Express Mail Label No. EV969121405US
U. S. Patent Application No. 10/664,581
Amendment dated December 5, 2006.

Charles E. Biss
Ser. No.: 10/664,581
Filed: September 17, 2003
Art Unit: 2876
Our Docket No.: 283-381

For: Apparatus and Method for Verifying Print Quality of an Encoded Indiciu

ANNOTATED MARKED-UP DRAWING

Fig 2

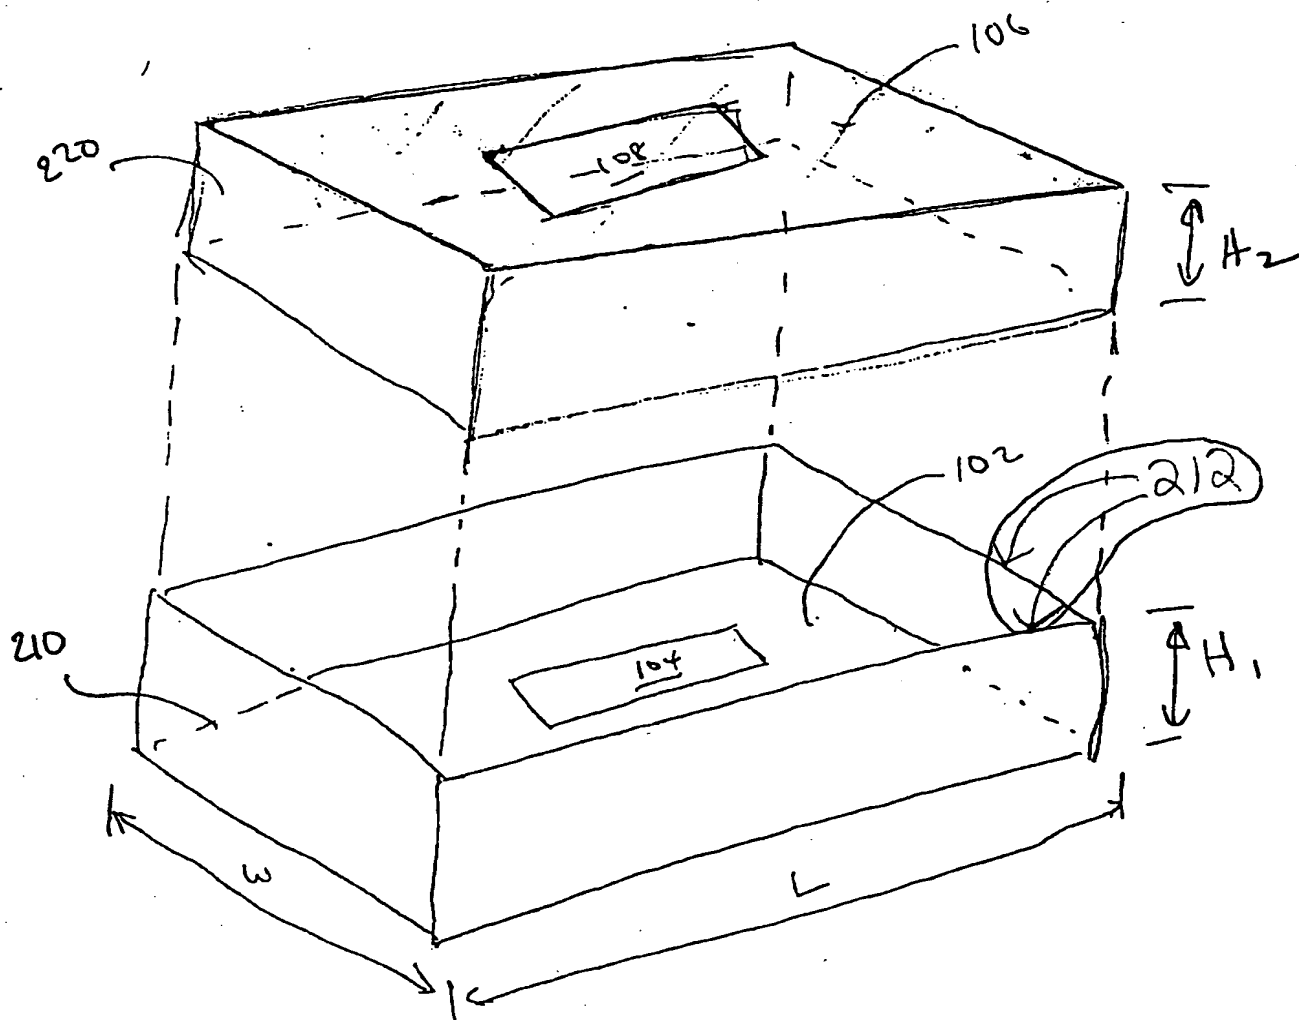
The Examiner states that the drawings are objected to as failing to comply with 37 CFR 1.84 (p) (5) because they do not include the following reference sign(s) mentioned in the description: "212" on Page 13, Line 11 of Paragraph 52 of the Applicant's specification.

In response to this objection, corrected drawing sheets for Figure 2, in compliance with 37 CFR 1.121(d) are attached. The reference sign "212" is now drawn on Figure 2 in a manner consistent with its description within Paragraph 52 of the Applicant's specification. As corrected, reference sign 212 points to two lines that intersect and define a location and an orientation of a plane. The plane is an example of a location of the mating surface 212 that is located at a pre-determined height (H1) above the first surface 104.
